**NUMBER:** 14-004-22 REV. A

Updated Fuel Filler Cap and Fuel Filler Tube

This bulletin involves updating the upper fuel filler tube and cap with improved versions.

2021 (JL) Jeep Wrangler

**Fig. 1**  
**Upper Fuel Fill Tube**

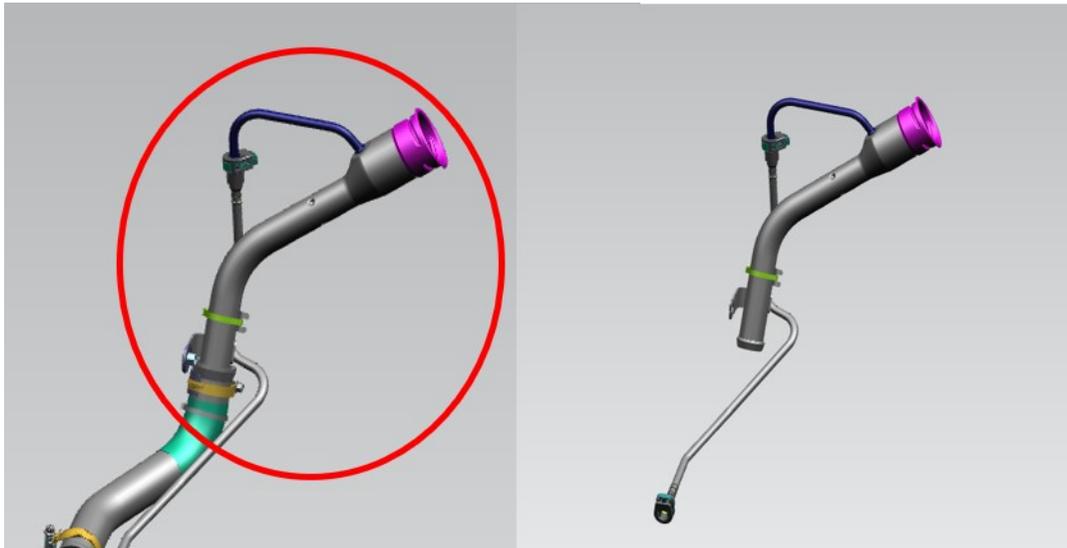
1. Remove and discard the fuel filler cap from the upper filler tube (Fig. 1) .
2. Install the new fuel filler cap on the filler tube (Fig. 1) .
